## PCN – Process Change Notification

Change:	WLP.2450.25.4.A.02
Date:	2016/08/16
Author	Bonnie Chen

Model#	Part Number	Changes
WLP.25 Patch Antenna	WLP.2450.25.4.A.02	Packaging rules changing.
		Add Part no.
		Amend length of pin from 2.25mm to 2.27mm.
		Amend Dimensions and Tolerance.

## New packaging rules

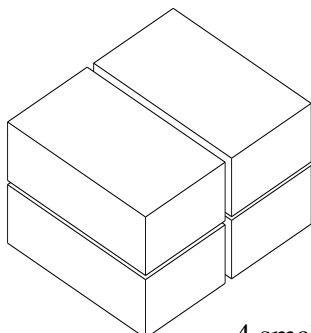
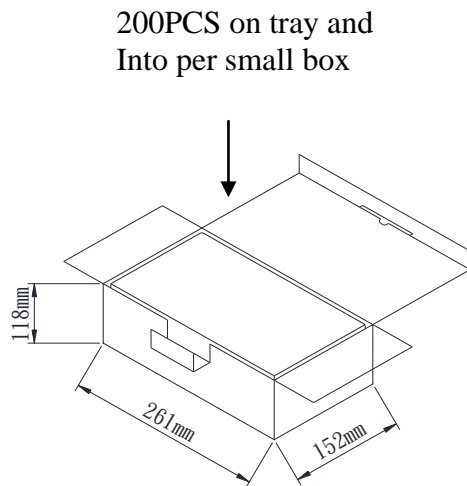
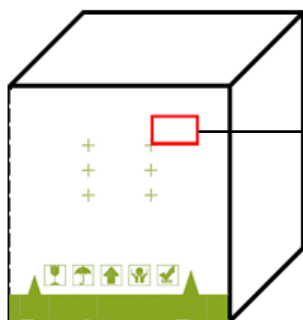
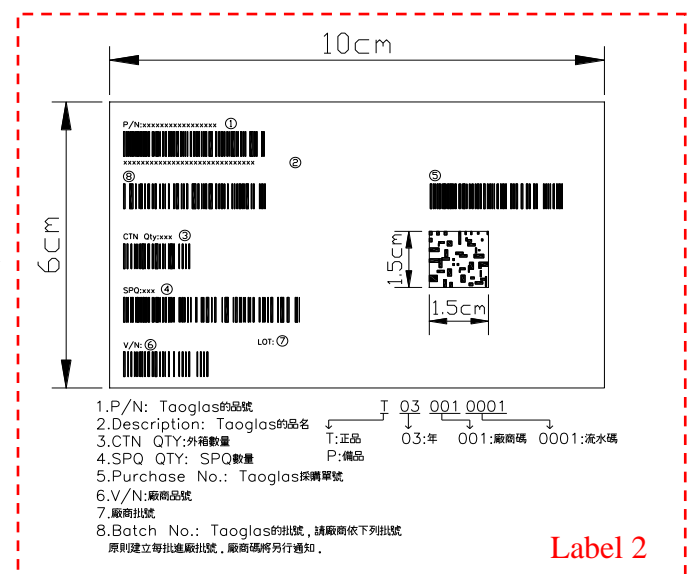
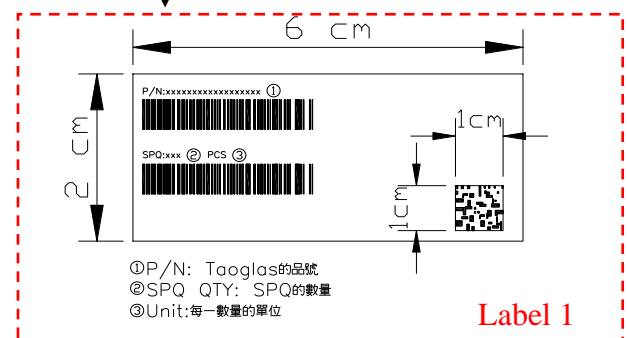
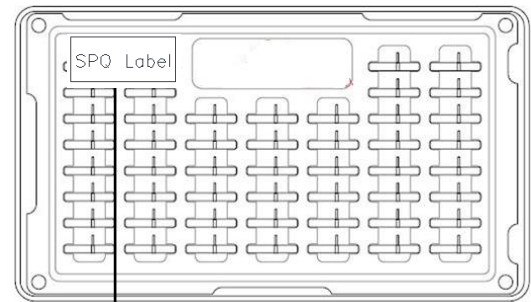
1. Due to Taoglas will input Barcode tracking process, we need to amend the packaging rules and labelling on barcode labels on standard packaging quantity bag and cartons.
2. Amend part no. on bom.
3. Amend length of pin from 2.25mm to 2.27mm
4. Amend Patch Size from 25x25mm to 25.1x25.1mm
5. Amend Tolerance.

4 small boxes

800 PCS per big carton  
330\*280\*270mm
